# Access Compliance Report

## Public Rights-of-Way

### (Pedestrian Signals)

Intersection ID: N/A	Main Street:	Cross Street: N/A	Location: N/A
ADA ID: 689915C4EF3C	Signal Type: One Push Button-Non APS	Overall Compliance: No	Severity Score: BTN 1: N/A BTN 2: N/A No BTN: N/A
Codes/Mitigation Info/Possible Solution		Field Measurements/Component Compliance

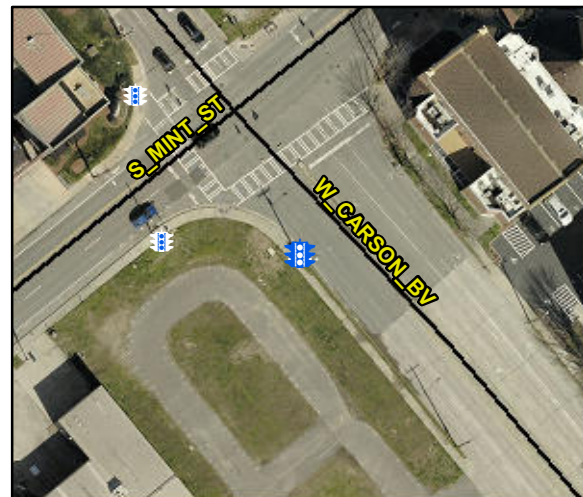
Yes	B 1 Clear Xing Direction?	ClearlyMarked	N/A	B 2 Clear Xing Direction?	N/A
	B 1 Crossing Direction	To NW		B 2 Crossing Direction	N/A
No	B 1 DistanceTo XWalk (in)	79.0	N/A	B 2 DistanceTo XWalk (in)	N/A
Yes	B 1 DistanceTo Curb (in)	36.0	N/A	B 2 DistanceTo Curb (in)	N/A
Yes	B 1 Diameter (in)	2.0	N/A	B 2 Diameter (in)	N/A

Possible Solutions: Replace Signal Push Button With APS Button on New Post. Remove & Relocate Sign.
